**Work Order ID 63890**

Item Name: Switch Plate

**D4014-1 SWITCH PLATE**

**From:** Harvey Siemens [hsiemens@dartaero.com]  
**Sent:** November 18, 2010 11:11 AM  
**To:** 'David Duval'  
**Cc:** 'Mike Petsche'; 'Eric Charbonneau'  
**Subject:** D4014-1 deviation

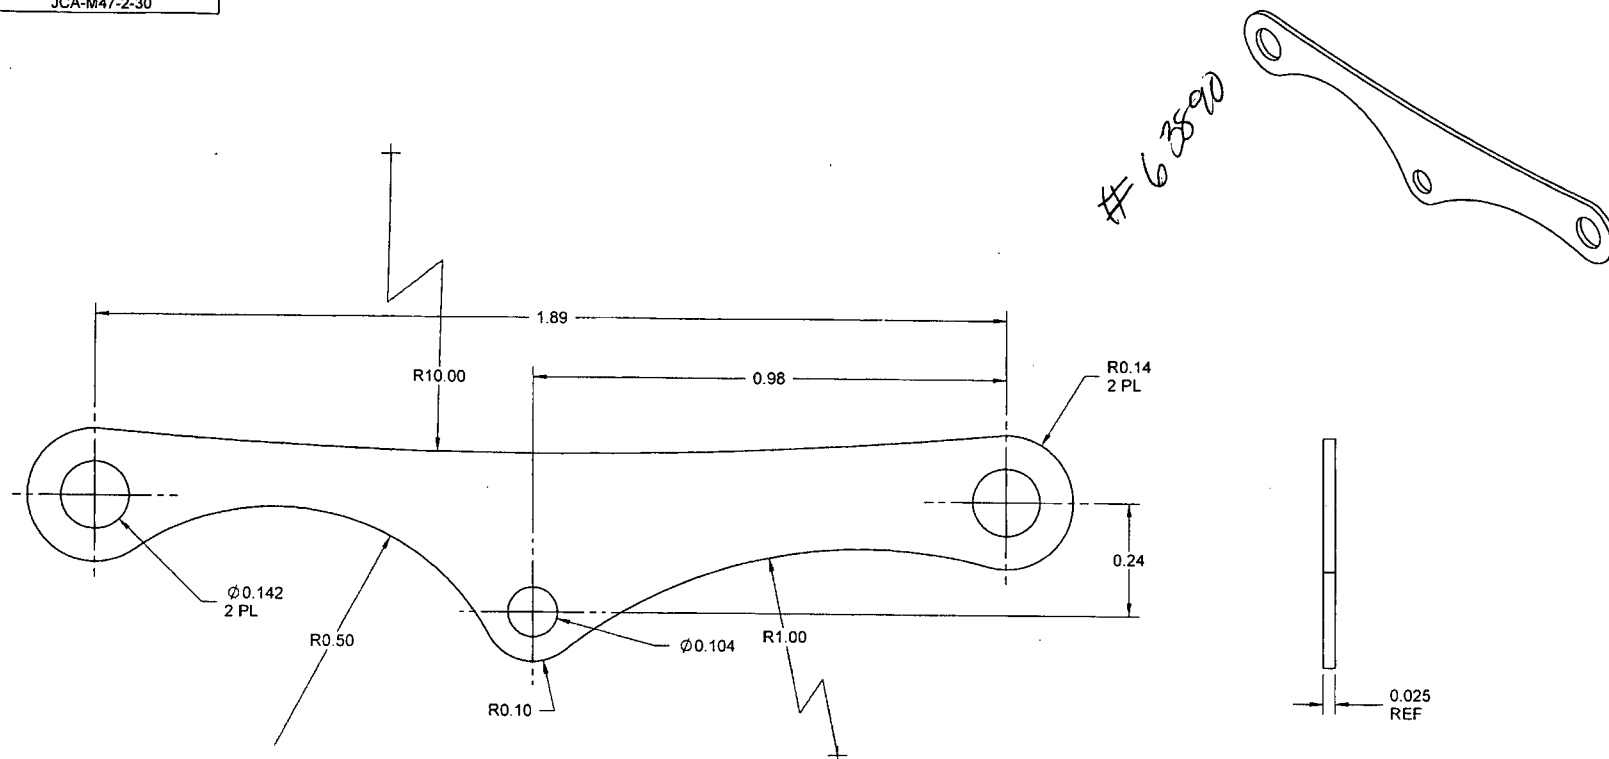
It is acceptable to make the D4014-1 from 0.032" thick material instead of the 0.025" material specified in the drawing.
